**Review of City of Aspen's
Castle Creek Hydroelectric Project
Aquatic Resource Documents**

January 14, 2011

**Greg Espegren
Aquatic Specialist
P.O. Box 4115
Eagle, CO 81631**

This report is based on a review of the City of Aspen's Castle Creek Hydroelectric Project documents pertaining to the stream health and aquatic resources of Maroon Creek and Castle Creek. The purpose of this report is to evaluate whether Aspen's documents, reports, studies and conclusions adequately addressed the potential biologic impacts that may accrue to Maroon Creek and Castle Creek as a result of the proposed hydroelectric operations.

Figure 2. Maroon Creek Average Year Hydrology (MEC Figure 8)

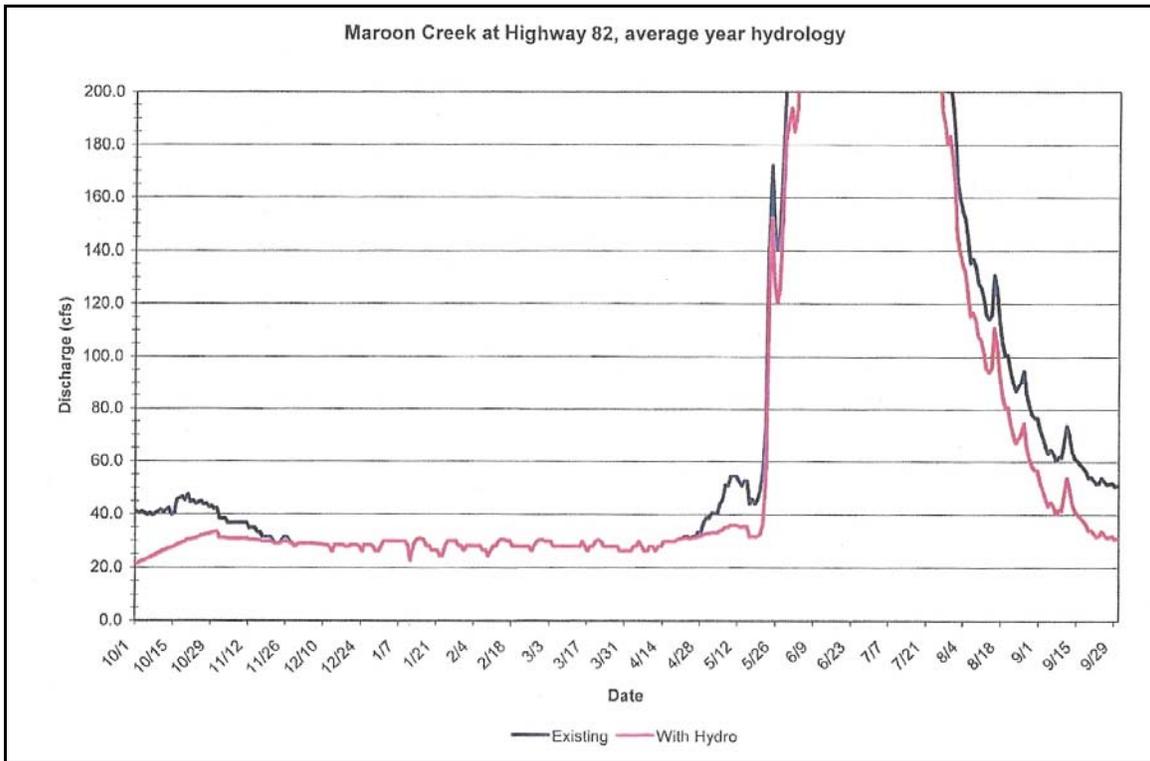
Figures 7 through 10 of the MEC report compare expected changes in streamflow on Maroon Creek at Highway 82 between pre- and post-project conditions for wet, average and dry years. These graphs indicate that the greatest percentage changes in flow between “existing” conditions and “with Hydro” on Maroon Creek will occur during the late summer, fall, and early spring months (see Figure 2 below). Reductions in winter flow may also be expected in wetter than normal years (*MEC report Figure 10*).

Figure 3. Castle Creek Average Year Hydrology (MEC Figure 14)

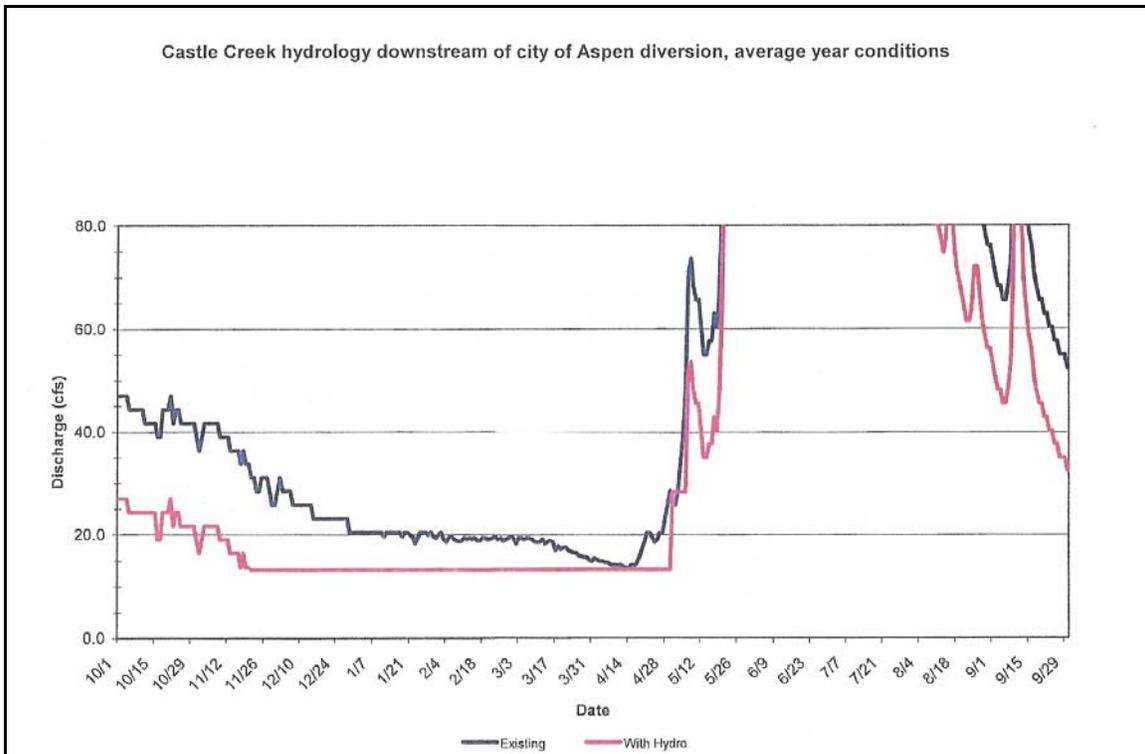
Figures 11, 14, 15, and 16 of the MEC report compare expected changes in streamflow on Castle Creek in the 2.4 mile stream reach below the diversion structure and above the hydropower return flow point for pre- and post-project conditions in wet, average and dry years. Once again, these graphs indicate that the greatest percentage changes in flow between “existing” conditions and “with Hydro” on Castle Creek will occur during the late summer, fall, and early spring months. These graphs also indicate that winter flows will be reduced to baseflow amounts for extended periods of time in all year types (see Figure 3 below).

A review of Figures 14 and 15 from the MEC report indicates late summer and early fall flows will be rapidly depleted and that the period of time Castle Creek will experience baseflow conditions will be extended from November to May of average and dry years. In contrast, baseflow conditions were rare or nonexistent under pre-project conditions. Figures 7, 8, and 9 show similar depletions to Maroon Creek during the late summer, early fall and spring portions of the hydrograph. The Walsh and Hillman and Chapman studies referred to above on Snowmass Creek and Maroon Creek suggest these prolonged baseflow periods on Maroon and Castle Creek may negatively impact overwinter survival of adult trout and trout eggs.
